# CABINET MEMBER FOR HIGHWAY MANAGEMENT – 26 JANUARY 2023

**GARSINGTON: PROPOSED 20MPH SPEED LIMITS**

Report by Corporate Director, Environment and Place

Annexes Annex 1: Consultation Plan

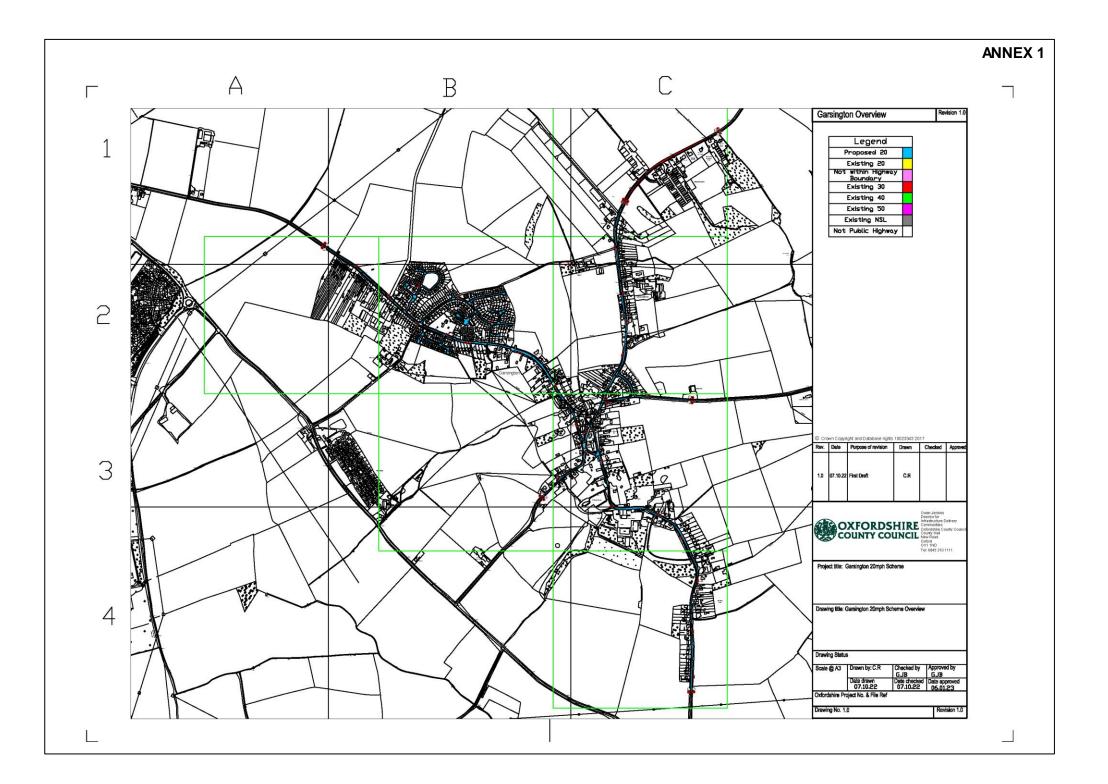
7. Thames Valley Police re-iterated their views on OCC's policy and practice regarding 20mph speed limits; they consider their response as 'having concerns' rather than an outright objection. Stagecoach Bus Company responded but had no objection or comments to make. The Oxford Bus Company support some of the proposals but object to the extent of the limits citing those on Oxford Road and Southend; in these locations they believe the lower limits to be unnecessary and will lead to an inevitable reduction in the bus service the operator is able to offer. Garsington Parish Council support the proposals.

- 8. 13 online respondents expressed support and 7 (including one listed as 'having concerns') objected. The objector's reasons included the proposals being unnecessary (2), 20 limits only required in the village centre (2), to instead provide better pedestrian and cycle facilities (2), and against the proposals in principle (2). The objector from a distance away submitted their standard objection wording including potential hazards from cyclists overtaking cars adhering to the proposed limits.
- 9. The Parish Council reported 68% support for the proposals amongst residents when surveyed as part of a wider parish plan.
- 10. Those who responded online, were also asked whether if the 20mph speed limit proposals were implemented, would it likely influence a change to their mode of travel in the area, the results of which are shown below:

(3) Interim Managing Director, (Oxford Bus Company)	However, for the section of Oxford Road between 27 Oxford Road and your proposed return to NSL after 197 Oxford Road, we would object to these proposals. Similarly we would object to the proposals for the section of Southend between 138 Southend and 59 Southend.
	In these areas, road widths are wider, a separate footway for pedestrians exists, and there are no active frontages that would encourage or lead to frequent and planned mixing between vulnerable road users and motorised traffic. Collectively, these sections constitute some 1.9km in length of road which is served by bus route 11, a route which is already having its running time challenged by over-application of 20mph limits in Chalgrove (a 0.9km section of which we previously objected to) as well as increased traffic congestion in East Oxford around the Plain Roundabout. We have already had to submit a revised timetable for service 11 to take account of these increases in running time, and therefore further unnecessary increases would be highly likely to lead to further reductions in this service.

(7) Local Resident/Member of public, (Garsington, Oxford Road)	<b>Object</b> - A 20mph limit in Garsington is sensible for the area around the school and at the hairpin bend at the centre of town; also for the area of the Green. But it makes little sense, and simply will be ignored by all through traffic, for the longer stretches where there are rarely pedestrians at all. Most of the four main arterial roads Oxford Road, Wheatley Road, Southend, and Petiwell, are in effect busy 'B' roads anyway for most of their lower extent, even within the village, and it is quite pointless to turn these into 20mph. So a positive proposal is to place a 20mph limit in the centre within a decent radius of the school so on the Wheatley Road from North Manor in; on the Oxford Road from Fox Close in; on Pettiwell from the top where the pavement stops, fifty metres short of the bus stop; and on Southend from the church up. The carrot for this is that people will genuinely obey a 20mph at the top in the interests of the school (and I have children at it so think about this a lot!) but the stick is that a 20mph from the village boundaries will be ignored everywhere within the village by everyone coming through, and won't protect our children at all. So do something targeted, or do nothing and save your money. (A good comparison is the alternative 20 and 30 at the top of Iffley from Rose Hill to Iffley Road, which does make sense.)

12. The objections are similar to those expressed and considered in earlier schemes which were then not deemed to warrant a change in proposals. While the Oxford Bus Company response is well-considered the proposals meet the intentions of County Council policy that initiated them.

13. The main purpose of the scheme is to improve road safety and to encourage greater use of active travel by reducing speeds; this will also reduce accidents. The aim of reducing speed limits is to change driver's mindsets to make speeding socially unacceptable and make more environmentally friendly modes of travel such as walking and cycling more attractive – and also reduce the Counties carbon footprint. This forms part of a countywide programme of works that seeks to deliver 'a safer place with a safer pace'.
